1 NORTH TO SOUTH AT DOOR SECTION
A-301 1/4" = 1'-0"

3 NORTH AND SOUTH SHEAR WALL BRACING SECTION
S-503 1 1/2" = 1'-0"

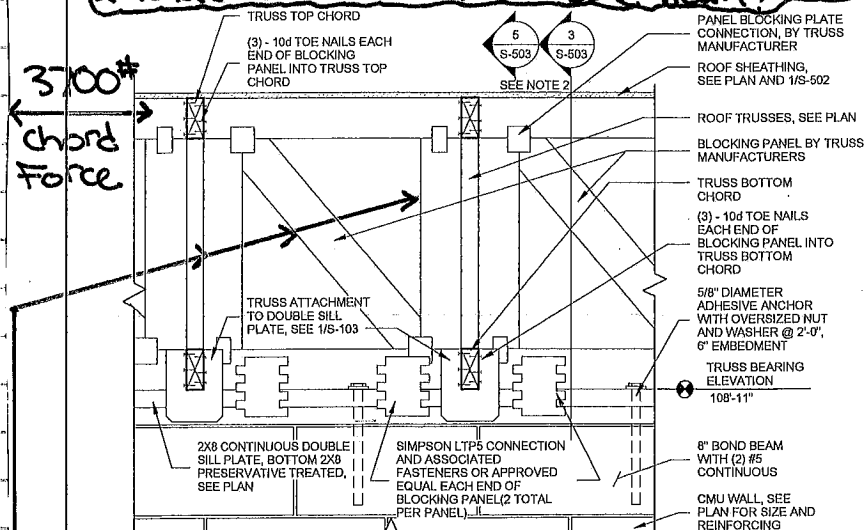
Does each Blocking Panel have to transmit the 3700# chord Force into the Bond Beam or do all of the Blocking Panels share in transmitting a total of 3700# into the bond Beam?

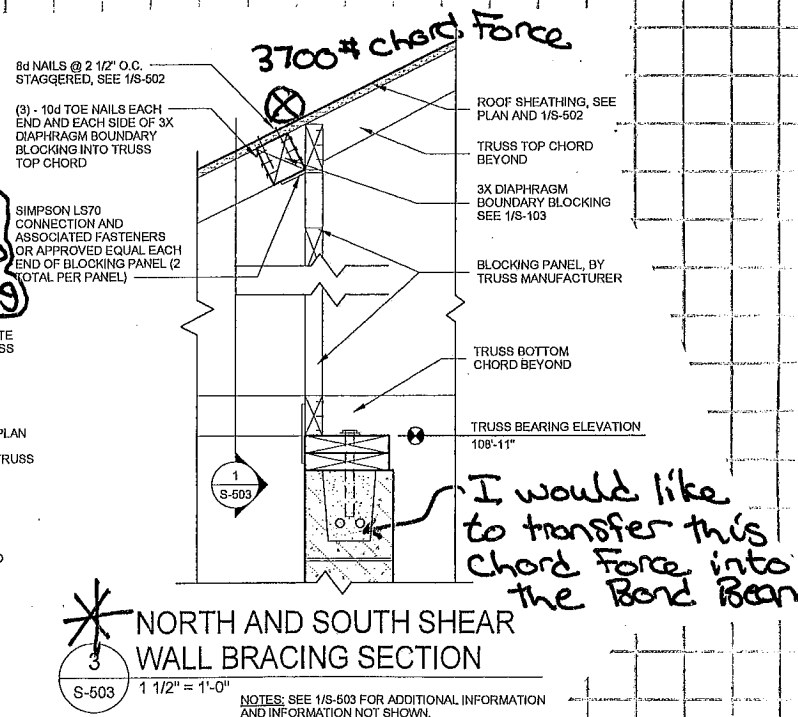
Blocking Panel/Panels used to transfer chord Force into Bond Beam
